Subject: FW: Attn. Development Assessment - DA2022/1128 Objection Letter

DA2022/1128 - 38 The Drive, Freshwater.

Objection Letter from Angelo - Owner of 36 the Drive, Freshwater.

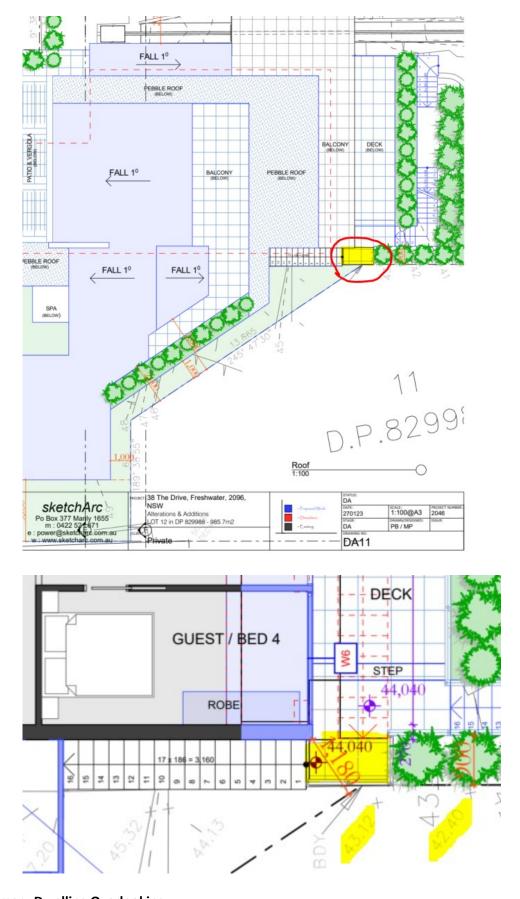
- The Front Wall of Secondary dwelling still has less of a front setback than the front wall of 36 The
 Drive. The front setback is also less than the recently built Secondary Dwelling 6 Coastview Place,
 which is located on the northern side of the proposed Granny Flat of 38 The Drive. This Secondary
 Dwelling has a minimum front setback of 3.5m at any one point. Council had allowed this
 concession from the normal front setback of 6.5m.

- The proposed secondary dwelling front wall sits approx. 350mm closer to the street than 36 The Drive. If both front walls were at least aligned, overshadowing would be minimised. We urge the council to require the front wall of the Secondary Dwelling be moved back another 350mm so that it at least aligns with the front wall of 36 The Drive. We note this request concedes that the proposed granny flat North-East wall corner would be set back from the front boundary approx. 1.6m, which is closer to the front boundary than any other nearby property, and does not complement the existing neighbourhood character of the surrounding buildings.

- The proposed glass balustrade to the front balcony of the Secondary Dwelling does not address the privacy concern that was raised. The slope of the natural ground does not allow for planting to provide privacy screening. It is still possible for occupants of the Secondary Dwelling to look directly across the lower balcony of 36 The Drive and into the Ground Floor Bedroom and Living. Privacy Screening will be required to prevent direct overlooking between balconies and into bedrooms. The height of such privacy screening should not cause additional overshadowing. (see image below).

o The Green Roof above the Secondary Dwelling is another point of objection. Whilst we welcome the lowering of the Secondary Dwelling roof height to preserve #36's existing views across the site to the beach, headland and ocean beyond, we worry that rooftop planting will quickly grow and block these established Northerly views. If council cannot condition a permanent height of green roof landscaping, we ask that the roof be changed to a medium to dark coloured roof, or concrete roof with pebble ballast would be preferred. If a green roof with soil and landscaping is to be approved, even moderate sized planting will cause substantial view loss from the only North-facing Living Room window. Without a view-loss diagram prepared by the applicant, we have prepared a diagram that attempts to illustrate the potential view loss from the secondary dwelling rooftop planting. OBJ-05 38 The Drive 2023 DA Objection Diagram.pdf

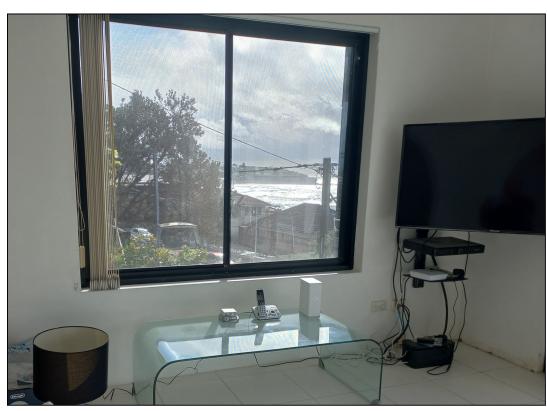
• We note that the extent of elevated bedroom and living room windows directly overlooking the rear yard of 36 The Drive is even more evident with the removal of the external vertical screens.

- The floor of Bedroom 5 (RL 47.33) is approx 1.8m above the natural ground level. A 1.8m high boundary fence will not prevent total overlooking of 36 The Drive's property.

- The floor of the Entertaining Area on Level 1 (RL50.80) is approx 2.8m above natural ground level at the boundary, 1m away from the window glazing. Boundary Fencing will not prevent total overlooking of 36 The Drive and no external privacy screens are proposed.

CONCERN OVER VIEW LOSS FROM LANDSCAPING AND PLANTS GROWING ON THE PROPOSED GREEN ROOF TOP.

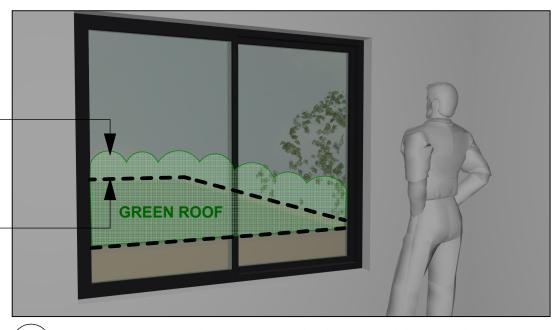
PROPOSED SECONDARY DWELLING ROOF PARAPET RL31.45. DOTTED LINE COPIED FROM CAD IMAGE BELOW.

A pebble ballast concrete roof or non-reflective metal roof would ensure Northerly ocean views are not lost over time from #36
